THE CLEVELAND ELECTRIC ILLUMINATING COMPANY

August 9, 1985
PY-CEI/NRR-0313 L

Perry Nuclear Power Plant
Docket Nos. 50-440; 50-441
Fracture Toughness
RCPB Materials
SER Confirmatory Issue 17

Figure 5.3-2

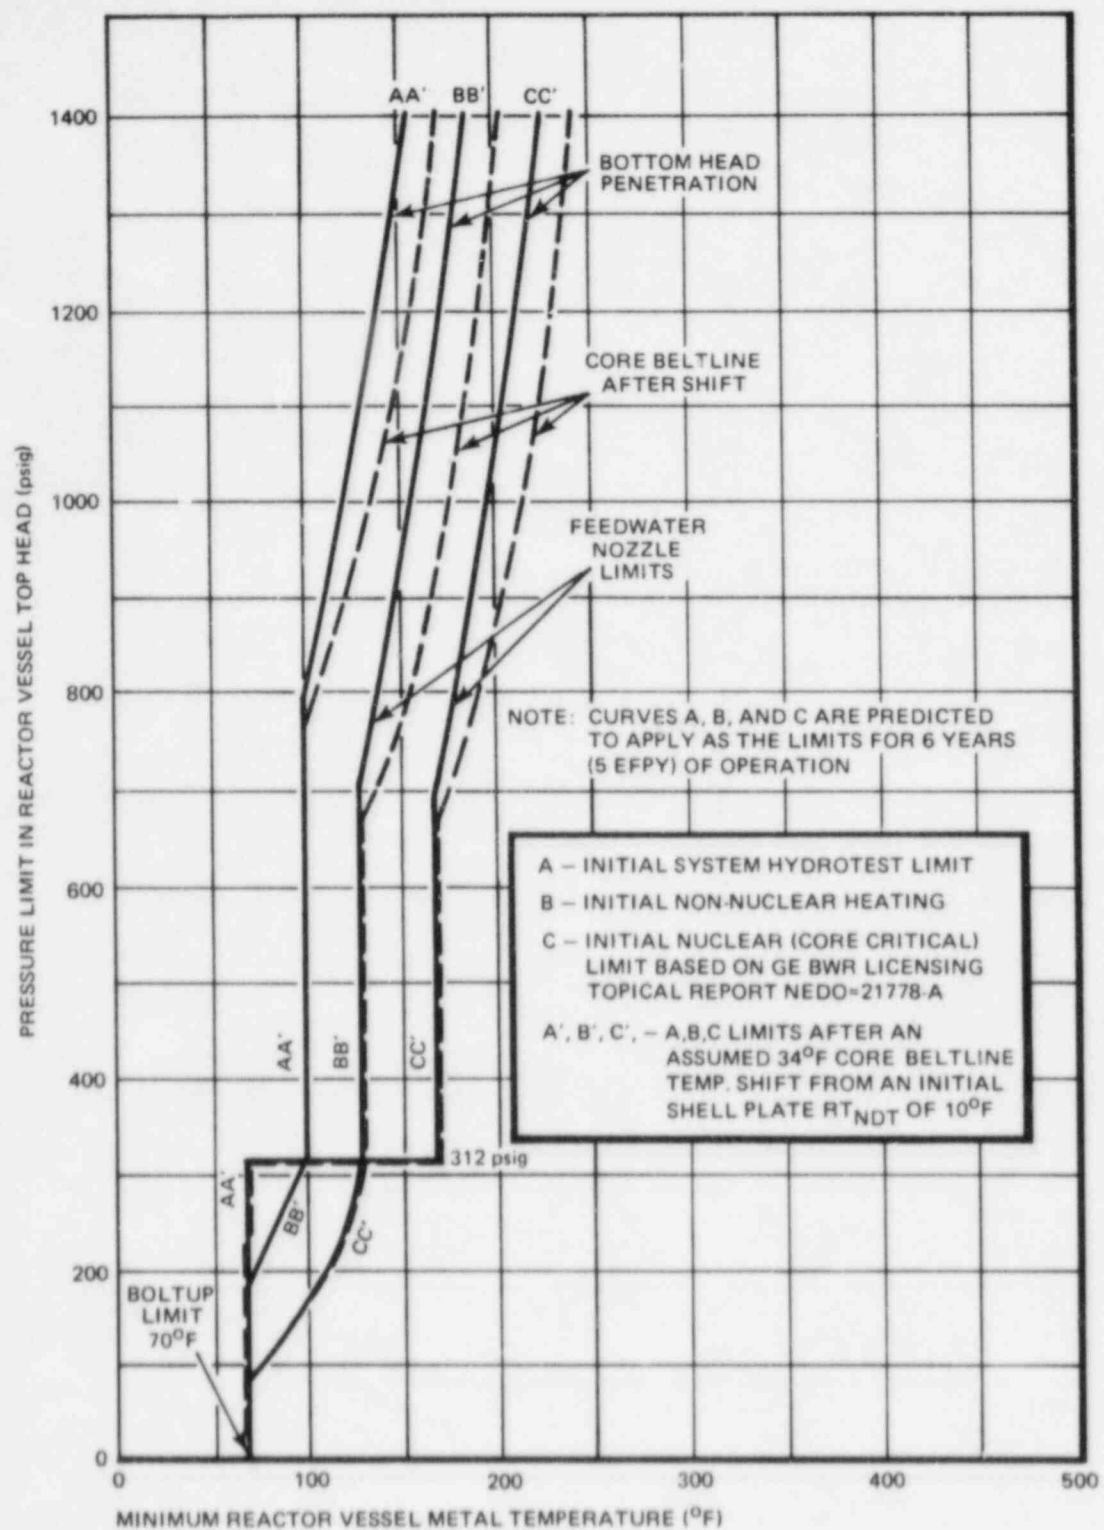
The fracture toughness analysis for system pressure tests resulted in the curves labeled A shown in Figures 5.3-2 (Perry 1) and 5.3-3 (Perry 2). The curves labeled "core beltline" are based on an initial RT_{NDT} of 10°F for the plate material for Perry 1, and an initial RT_{NDT} of -20°F for the plate material for Perry 2.

The fracture toughness analysis was done for the normal heatup or cooldown rate of 100°F/hour. The temperature gradients and thermal stress effects corresponding to this rate were included. The results of the analyses are a set of operating limits for non-nuclear heatup or cooldown shown as curves labeled B on Figures 5.3-2 and 3. Curves labeled C on Figures 5.3-2 and 5.3-3 apply whenever the core is critical.
